**Subject: MHI's Amended Response to US-APWR DCD RAI No. 740-5719
Revision 2 (SRP 06.02.02)**

**US-APWR Design Certification
Mitsubishi Heavy Industries, Ltd.
Docket No. 52-021**

RAI NO.: NO. 740-5719 REVISION 2
SRP SECTION: 06.02.02 – Containment Heat Removal System
APPLICATION SECTION: 6.2
DATE OF RAI ISSUE: 4/26/2011

QUESTION NO.: 06.02.02-64

Figure b-1 Film Condensation at Structure Surface

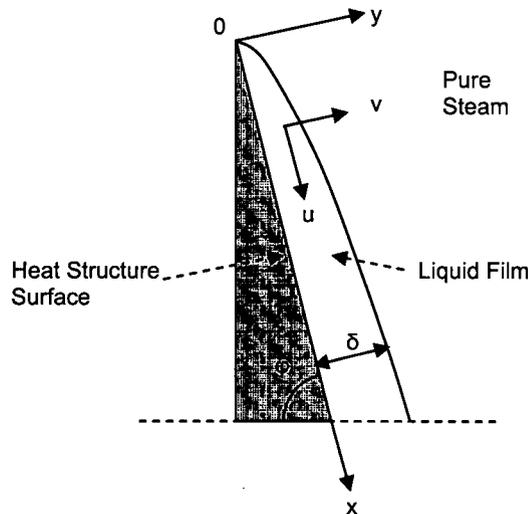
- o Condensate water on containment surfaces – Equation listed for film condensation correlation used to calculate film thickness could not be readily verified (reference in Japanese) and was not found in standard textbooks on heat and mass transfer. Appropriate reference and justification should be provided for the applied methodology and selected input values. Film thickness will be a function of the surface height. Justify estimated vertical surface area and corresponding heights

Condensate film thickness was calculated from Eq. 11 in the holdup volume calculation based on the fluid conditions. The calculation follows the methodology of theoretically solving the Nusselt film heat transfer correlation, which is widely known and is referenced from Reference 4 and 5.

By Eq.11, condensation liquid thickness on the surface of the heat structure is predicted. The height used for this calculation was 40 meters (about 130 feet), and the resulting condensation film thickness (based on 40 meters height) was applied to all surfaces. The vertical portion of containment from second floor level (EL 25'-3") is about 129 feet. If the vertical height (x) increases, the liquid film thickness also increases as shown in Eq. 11. However, the liquid thickness calculated based on a 40 meter height was conservatively applied to all surfaces.

Figure b-2: Sketch of flooding overflow curb

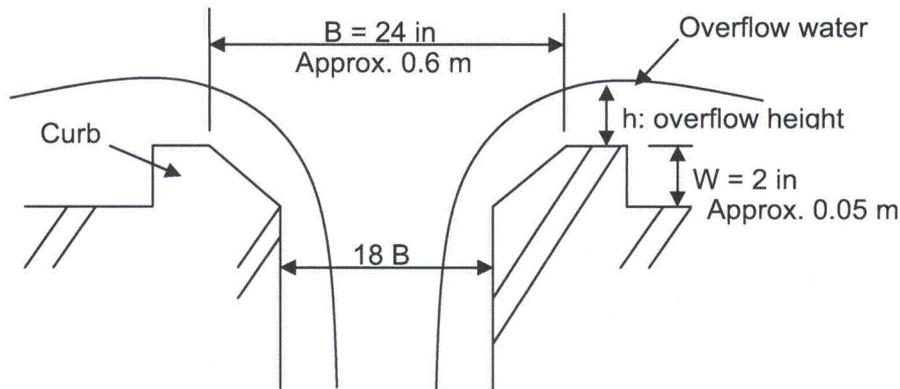
- o Water retained on the floors – Reference and basis was not provided for selected equation (method of evaluation) or input values used to evaluate dynamic retention on containment floor (result was 6" water height above floor). No evaluation was provided for assessing the dynamic retention on upper floors in containment (assumed 2" height above floor). Please provide the reference and basis and for calculating the dynamic water retention heights to include method and input values.

Water depth on the floors is calculated based on the following general expressions.

Width of curb is designed to be approximately 600 mm (approximately 24 inches) as shown in Figure b-2. Width of curb shall be as follows;

$$\begin{aligned} h &= (Q / (C \times B))^{2/3} \\ &= (0.1007 / (2.259 \times 1.9))^{2/3} \text{ m} \\ &= 0.082 \text{ m} \\ &\approx 0.1 \text{ m (Roundup)} \\ &\approx 4 \text{ in} \end{aligned}$$
